Planning Department Staff Report

Subject: 103 Alice Court
Application: PL-23-05805
Author: Lillian Zollinger, Planner II
Date: October 12, 2023
Type of Item: Modification of a Historic District Design Review

Project Summary: The Applicant Proposes to Modify the Proposed Single-Family Dwelling and Add a Second Garage Entrance.

Proposed Garage Modification

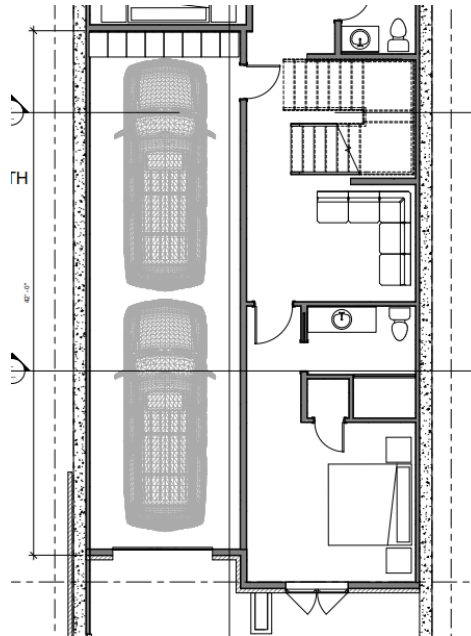
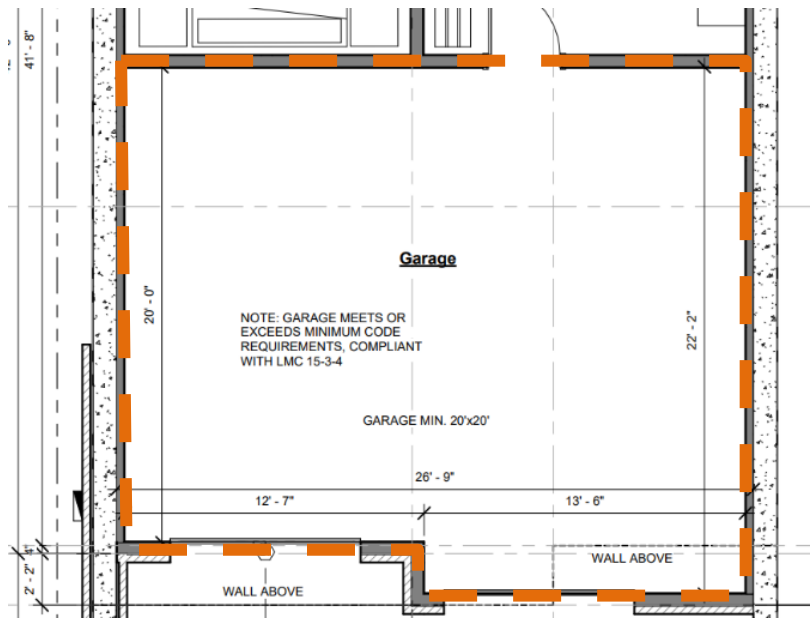
h) Parking Area & Driveways Pursuant to LMC § 15-3-6(A) , Single-Family Dwellings in the HR-1 Zone require two parking spaces.	Complies: The proposed home will have two parking spaces with two garage entrances. LMC § 15-3-4(A) requires a minimum 11 feet by 20 feet for a single-car garage space. The garages are compliant – the dimensions are 12 feet, 7 inches by 20 feet, and 13 feet, six inches by 22 feet. LMC § 15-13-8(B)(1)(h)(7) sets the maximum width for driveways in Historic Zoning Districts to 12 feet and the proposed driveway is compliant at 12 feet in maximum width at the curb. The applicant shall split the driveway at the garages into two 12' driveways by using pavers (see Condition of Approval 8. LMC § 15-13-8(B)(6)(a)(3) requires, "Garages featuring a side-by-side parking configuration shall maintain a 2 foot horizontal offset in the front wall plane." The proposal has a two-foot, two-inch horizontal offset.

Complies: The proposed home will have two parking spaces with two garage entrances. LMC [§ 15-3-4\(A\)](#) requires a minimum 11 feet by 20 feet for a single-car garage space. The garages are compliant – the dimensions are 12 feet, 7 inches by 20 feet, and 13 feet, six inches by 22 feet.

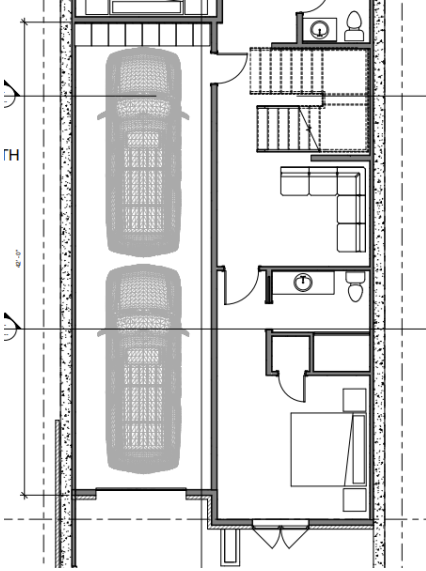
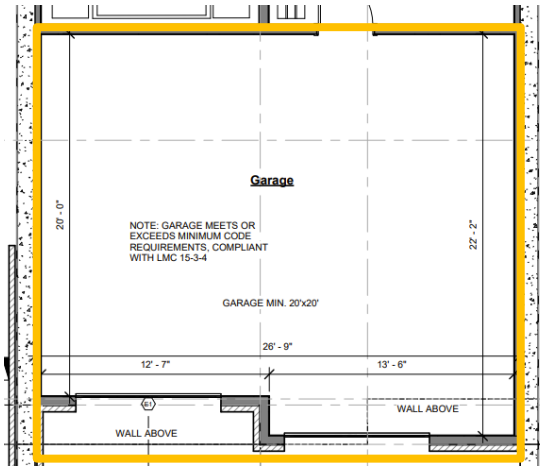
h) Parking Area & Driveways Pursuant to LMC § 15-3-6(A) , Single-Family Dwellings in the HR-1 Zone require two parking spaces.	Complies: The proposed home will have two parking spaces with two garage entrances. LMC § 15-3-4(A) requires a minimum 11 feet by 20 feet for a single-car garage space. The garages are compliant – the dimensions are 12 feet, 7 inches by 20 feet, and 13 feet, six inches by 22 feet. LMC § 15-13-8(B)(1)(h)(7) sets the maximum width for driveways in Historic Zoning Districts to 12 feet and the proposed driveway is compliant at 12 feet in maximum width at the curb. The applicant shall split the driveway at the garages into two 12' driveways by using pavers (see Condition of Approval X. LMC § 15-13-8(B)(6)(a)(3) requires, "Garages featuring a side-by-side parking configuration shall maintain a 2 foot horizontal offset in the front wall plane." The proposal has a two-foot, two-inch horizontal offset.

Previous Plan  Proposed Garage Modification 
a) Garages	Complies: The proposed home will have two parking spaces with two garage entrances. LMC § 15-3-4(A) requires a minimum 11 feet by 20 feet for a single-car garage space. The garages are compliant – the dimensions are 12 feet, 7 inches by 20 feet, and 13 feet, six inches by 22 feet.

6. New construction activity shall not physically damage nearby Historic Sites.
7. Final plans shall call out final grade within 4' of existing grade.
8. At the front of the garage, the Applicant shall divide the driveway into two- 12' driveways.
